JAFNPP

IMPROVED STANDARD TECHNICAL SPECIFICATIONS (ISTS) CONVERSION

ITS: 3.3.4.1

Anticipated Transient Without Scram Recirculation Pump Trip (ATWS-RPT) Instrumentation

**ATWS RECIRCULATION PUMP TRIP INSTRUMENTATION
TEST AND CALIBRATION REQUIREMENTS**

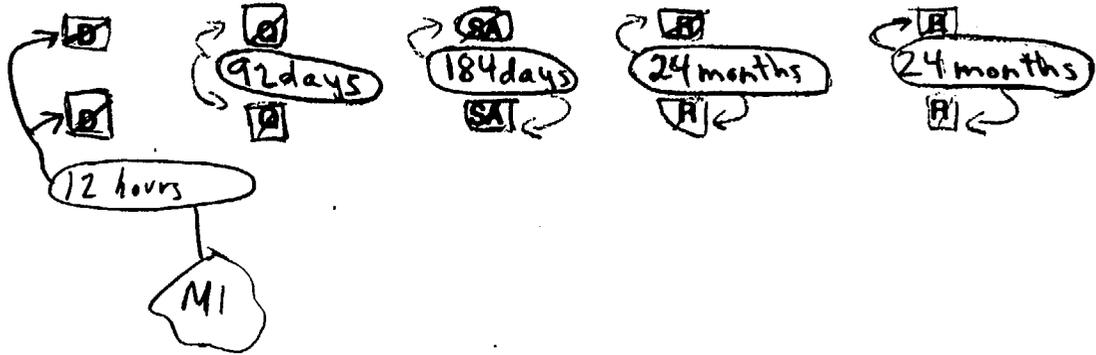
A8

A8 CTS 3.2.G makes reference to the limiting conditions for operations for the instrumentation that trip(s) the recirculation pumps in CTS Table 3.2-7. CTS 4.2.G requires the Recirculation Pump Trip instrumentation to be functional tested, calibrated and to test the associated logic as indicated in Table 4.2-7. This cross-reference to the Tables has been deleted since ITS 3.3.4.1 does not include a Table. All of the technical requirements of CTS Tables 3.2-7 and 4.2-7 are included in the ITS 3.3.4.1 LCO, Applicability, and Surveillances. Since this change simply deletes this cross-reference, this change is considered administrative. This change is consistent with NUREG-1433, Revision 1.

M1 CTS Table 4.2-7 requires a daily performance of an ATWS-RPT Channel Check. ITS SR 3.3.4.1 will require this test to be performed every 12 hours. The purpose of the Channel Check is to ensure that a gross failure of instrumentation has not occurred. Thus, performance of the channel check helps to ensure that an undetected outright channel failure is limited to 12 hours. This change is consistent with NUREG-1433, Revision 1.
